NATIONAL RADIO ASTRONOMY OBSERVATORY
Charlottesville, Virginia

SUBJECT: VLBA Electronics Meeting, April 4, 1985 - Discussion of the Front-End Monitor and Control System

VLBA
 FRONT-END CONTROL
 MODULE

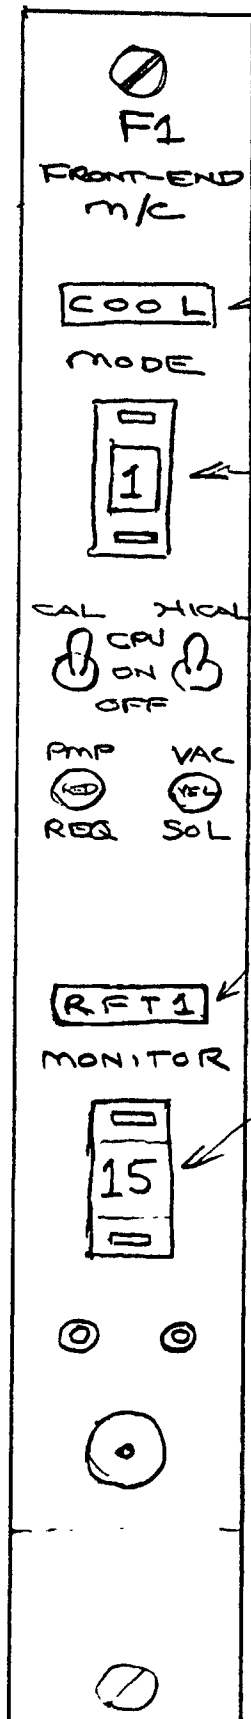
There is general agreement that the 25 conductor cable used to connect the prototype 8.4 GHz front ends to their modules is too restrictive. Sandy proposed summing the bias voltages of the second and later stages of the FET amplifiers, but this would release only four conductors. At this early stage in the VLBA development one would like to have at least, say, ten spare lines so that such things as feed pressure can be included if required. Ways of increasing the number of monitor points are as follows:

- (a) Include an analog multiplexer in the front end. There is some concern that if this is mounted in the card cage there could be digital pickup from the address lines.
- (b) Use a 37 or 50 conductor cable. The present 25 conductor cable uses the widely-available D-type connectors. Two cables of the present type between each front end and module is another possibility. One male and one female connector would be used at each end. One cable would carry only monitor voltages and could be unplugged from the front end without disturbing its operation to allow a local monitor box to be installed.

The two schemes outlined above could both be made to work well. They differ mainly in the location of the interface circuitry, which may seem to be a relatively small point, but at the meeting both had staunch advocates of their relative merits. Basically, the rack-mounted module scheme is intended to provide a rather elaborate parallel monitoring arrangement that would be available for all front ends at all times. The front-end-mounted scheme is based on the philosophy that the monitor and control interface should be close to the circuits that is monitors and controls, and long cables should be avoided.

The advantages of the rack-based interface system were carefully described at the electronics meeting, but subsequent conversations indicate that the case did not prove convincing. In making this judgement I give heavy weight to the opinions of those engineers who have spent a lot of time maintaining front ends in the field, particularly at the VLA. Although none of the NRAO facilities closely resemble the VLBA in operating conditions, the VLA comes closest. A number of people in this category felt that the rack-mounted analog system would not be much used in the long term. One important aspect in which it fails is that it cannot be seen by a person working at a front end (in most cases), and a further cable from the rack to the work location would be cumbersome. A small unit that plugs directly into a front end or into a front-end-mounted monitor and control unit would be preferable. Thus the present conclusion is that the second of the two possibilities is the better choice, and a detailed study of the front-end-mounted interface unit will therefore be initiated.
